SERVICE INFORMATION BULLETIN

APPLICABILITY: 2020MY WRX
SUBJECT: OBDII Diagnostic Connector and Body Integrated Unit (BIU) Mounting Brackets- Design Changes

NUMBER: 07-193-21
DATE: 04/07/21

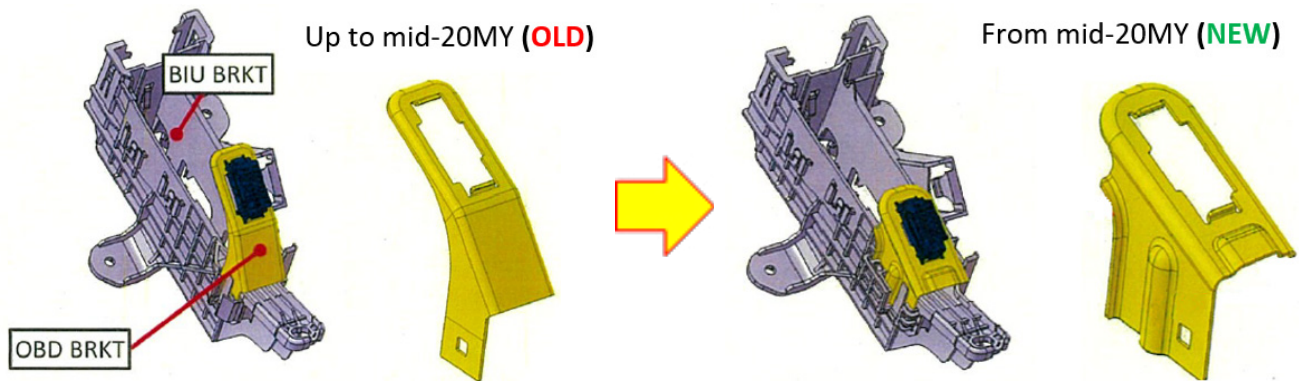
This Service Information Bulletin announces design changes made to the OBDII diagnostic connector and BIU mounting brackets to meet new OBD regulations for rigidity.

The new brackets were incorporated into production starting with VIN **L9834056**.

Description	NEW Part Numbers	OLD Part Numbers
BRACKET-INTEGRATED UNIT	88283VA020	88283VA010
CONNECTOR BRACKET-OBDII	81041VA060	81041FJ030

- The NEW parts are interchangeable with the OLD parts AS A SET ONLY.
- Never install the OLD parts on a vehicle originally fitted with the NEW parts.
- Component parts are NOT interchangeable between NEW and OLD.
